TECHNICAL BULLETIN

No: 06-50029

46-20049 Intercooler Tube Upgrade
46-20059 Intercooler Tube Upgrade

Intercooler Tube Upgrade Installation Instructions: 2004.5-2010 GM DURAMAX V8-6.6L (td) LLY/LBZ/LMM

Figure 1

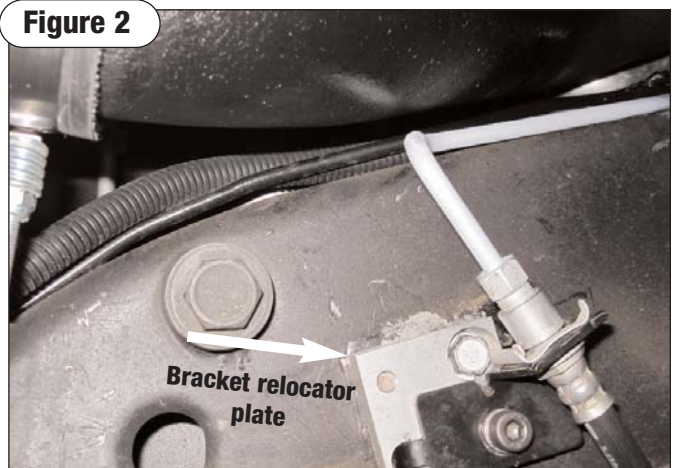
Interference may occur between the brake line and the aFe intercooler tube upgrade. This could potentially cause damage to the brake line. For these situations, aFe has developed a bracket relocate plate to ensure sufficient clearance.

Please check the gap between of the brake line and the aFepower intercooler tube upgrade (See Fig. 1). Does the brake line touch the intercooler tube?

If it touches or is very close, please contact aFePower by phone at (951)493-7100 or email tech@afepower.com to request bracket relocater plate (P/N 05-60049). Upon receipt of proof of purchase, aFePower will send you the bracket relocater plate free of charge.
